**Draft Plan of Subdivision (DPOS) and Zoning By-law Amendment (ZBA) Application**

**0 Agnes Street**

**DART Comments on Second submission**

**City File:** DART 21T-23001C / DART RZ 2023-0002 **Weston File:** 11064

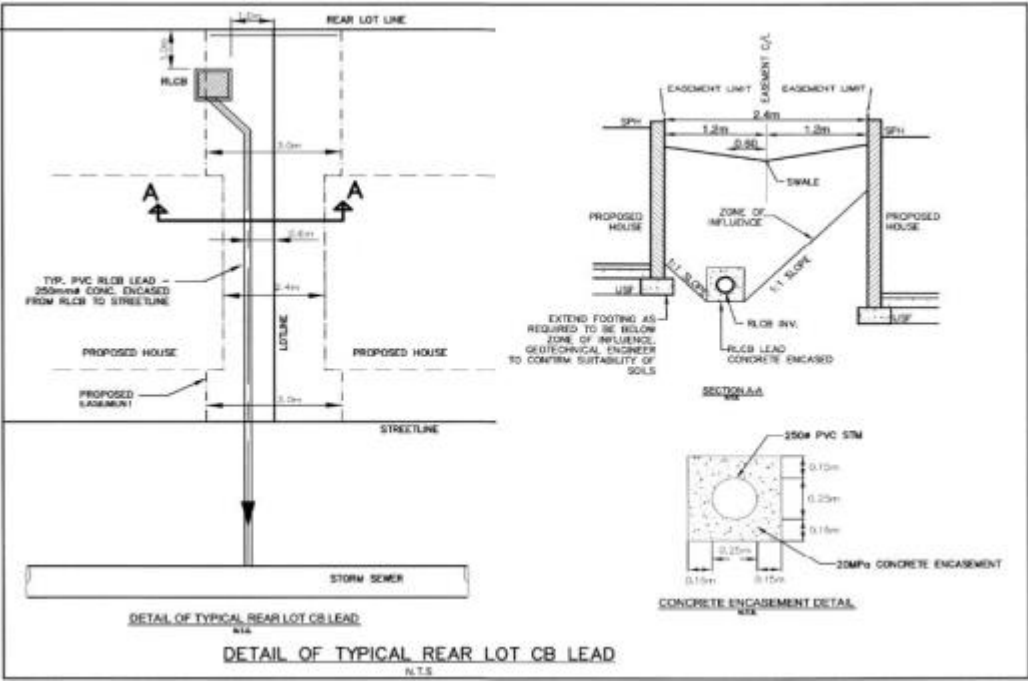
<p><b>10.</b> All earthworks operations on the site including grading, earth importation, and earth removal are to comply with O.Reg. 406/19 – Management of Excess Soils.</p>	<p>Noted</p>
Grading	
<p><b>11. An updated survey</b> is required as the infrastructure shown on Emeline Street and surrounding the proposed development is incorrect and outdated. As previously advised (and material provided to the applicants engineering consultant) the Town undertook a Storm Drainage Study – Alton Estates Phase 1 and drainage improvement works as recommended in the Phase 1 studies was completed in the Emeline Street ROW adjacent to the subject development in 2020. Works included ditch cleanout/improvement and installation of additional CBs, DIs, and OGS units. <b>Civil plans should be revised</b> to reflect the previous completed drainage improvement works through the previously mentioned Capital Project in</p>	<p>At the time of commencing detailed design, the first step will be to obtain an accurate and detailed existing conditions survey.</p>
